Joint Statement between the Applicant and Mr Stuart Mee of Manor Farm, North Ockendon,

Manor Farm Options Report for Lower Thames Crossing

Prepared for Stuart Mee

Figure 1: Catchment area based on FEH and LIDAR boundaries.

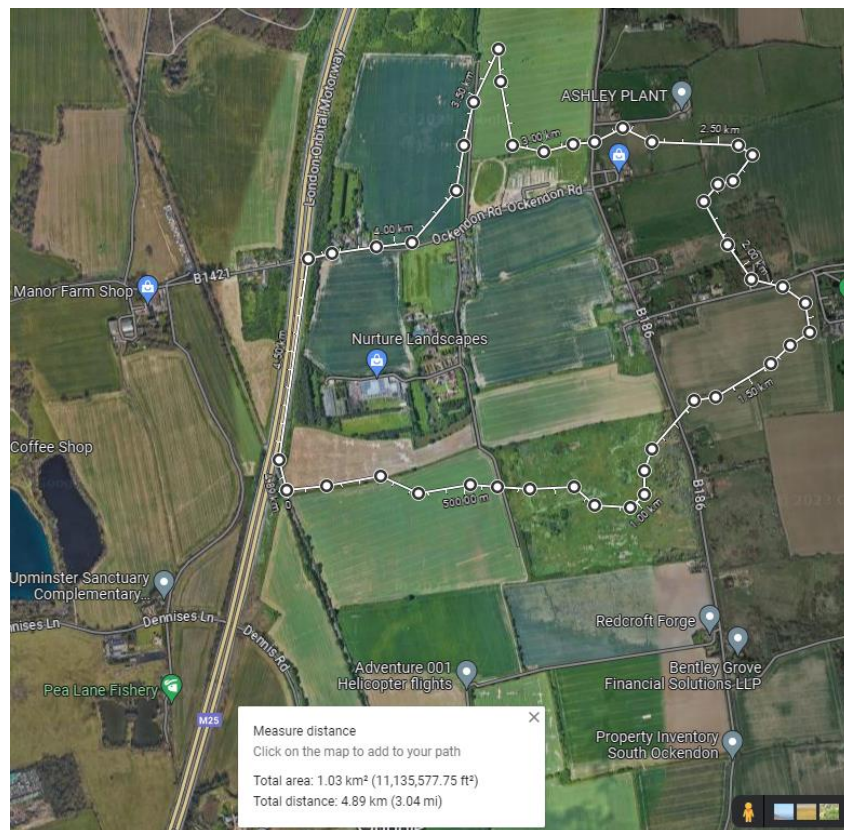
The LTC's work was based on a catchment size of **0.593km²**. This is a lot smaller than the original catchment area calculated by Paul Bradford (1.6km²) and is also much smaller than the catchment defined by the FEH catchment boundary and the LIDAR data. The reasons the LTC give for reducing the catchment area relate to the roads acting as a hydrological boundary and the fact that catchment size used gave the best fit for the recorded peak flows

However, there is no evidence to suggest that the roads are acting as a barrier. Road drainage will usually add to the local hydrological inputs unless it is culverted into another catchment, which seems unlikely. In addition, using the data they collected to inform the catchment size is something we would challenge because of the issues we have with the quality of the data, as set out in section 2.2 below. Therefore, I don't see any reason not to include some of the wider catchment. Keeping to the LIDAR and FEH boundaries, we get a catchment size of **1.03km²** (see Figure 1). This is still smaller than the area defined by Paul Bradford. However, Paul did not have access to the LIDAR data.

It is noted that LTC have included an alternative catchment area in their updated water balance report, with an area of 0.992km². This is very similar to the catchment area we have defined in Figure 1. Therefore, we dispute LTC's conclusion that the most appropriate catchment size is 0.593km². We believe the area of 1.03km² is more appropriate.

There is uncertainty regarding the catchment area used by LTC. We would disagree with the area chosen for the first draft of their water balance report and welcome the inclusion of the larger area (0.992km²) in their redrafted report. The area shown in Plate A.1 of LTC's report is not materially different than what we have proposed in figure 1 of this report and therefore we continue to use the catchment area of 1.03km² as we have calculated it to be.

Figure 2: Map of the proposed Re-instatement and make-up options. New elements are in orange, existing elements are in gray/black.

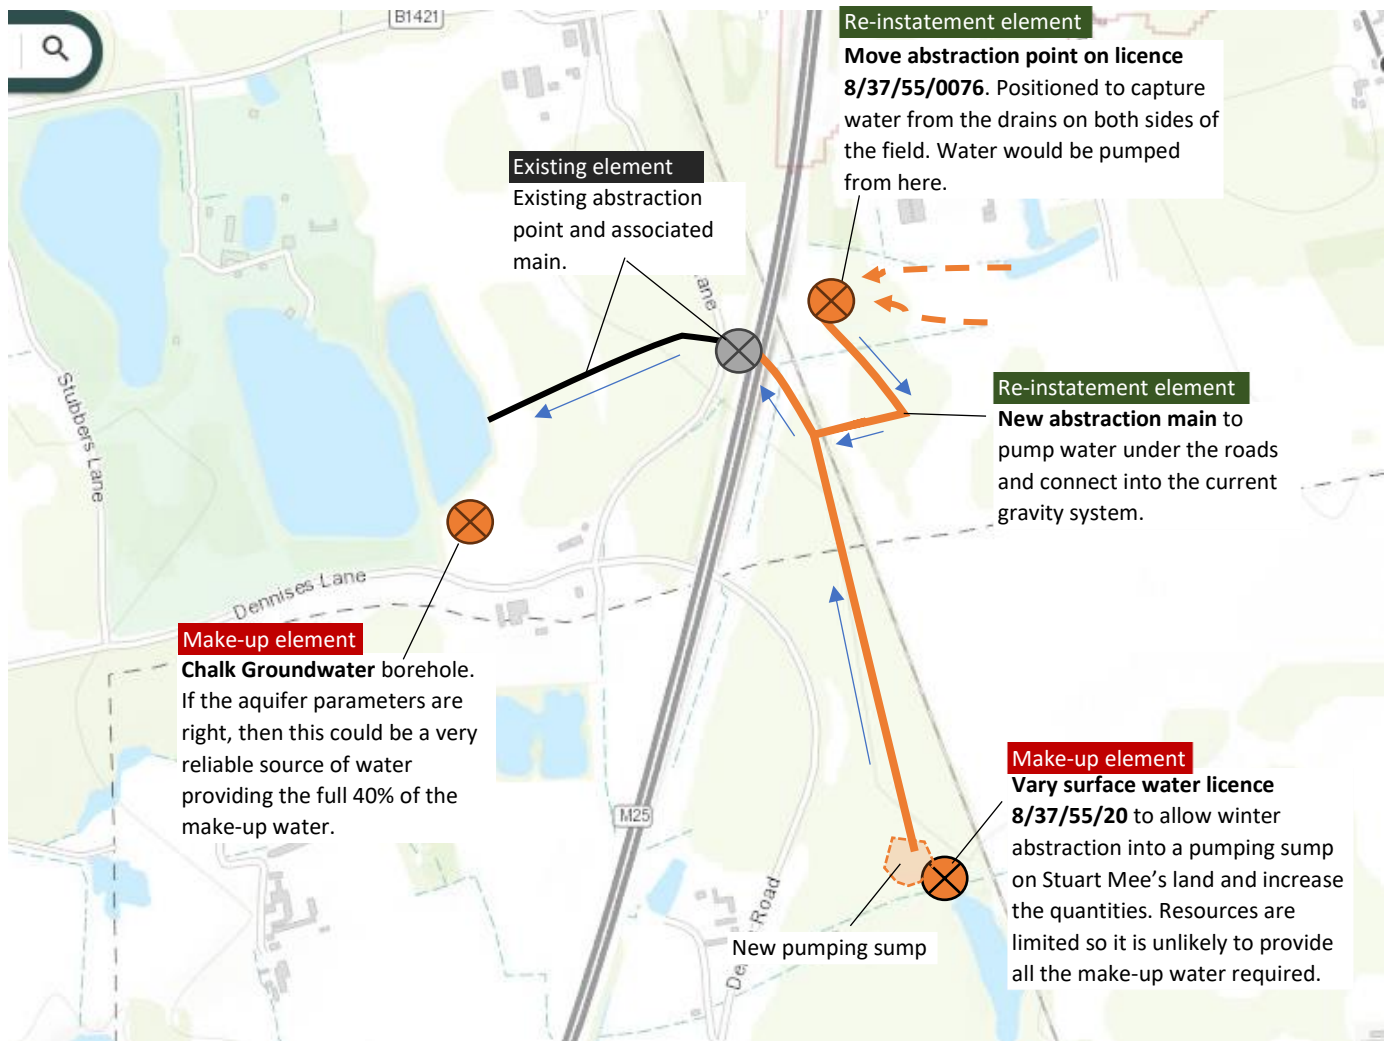
This will mean re-locating of the abstraction point on licence 8/37/55/0076 to the east of the proposed new road. At the new abstraction point, water would be directed into a pumping sump before being pumped around the new and existing roads/railway, and into the current gravity system that runs west of the road to the reservoir. (see re-instatement elements in green on Figure 2)

Licence 08/37/55/0020 was issued back in 1966 and solely was a recognition that an abstraction had previously existed at this location. There would not have been any technical assessment to confirm the viability of such an abstraction. Recent return data implies no abstraction has been undertaken. The expectation based on the catchment area is that the available resource is limited and it may require full saturation of the shallow deposits before flows might rise to any meaningful level. We hold no gauged flow data that could imply the quoted volumes might be feasible. The normal expectation is that a period of flow gauging/data collection is undertaken to support any request to increase the proposed abstraction rates. This would need to incorporate those wet periods.

It is standard to incorporate a HOF (flow constraint) condition. This is to protect flow integrity but may also need to consider other factors (subject to internal consultation comments). The best solution will be to incorporate a constraint value into a local restriction immediately downstream of the abstraction point or combine it into the intake works. This proposal and the subsequent investigation will be heavily reliant on the flow data that needs to be collected. Without such data it is likely to be difficult to take forward such a proposal

The NGR provided places the abstraction point between the Stubber's Outdoor Pursuit Centre (West) and Kemps Farm (East). The location is also surrounded by various conservation designations and a small ditch system. There could be various challenges and monitoring requirements to understand the relationship between all these other factors alongside a proposal to abstract water from the shallow deposits. This would need to be understood and potential safeguards incorporated into any proposal taken forward. There are unknowns on

both the potential yield available and its possible implications for any identified nearby water based features. Where the decision is taken to pursue this particular option then my colleagues in the Area Groundwater team will deal with such a request. They will require an enhanced pre-application submission to allow a review of the proposal and any relevant supporting technical data that you can provide.
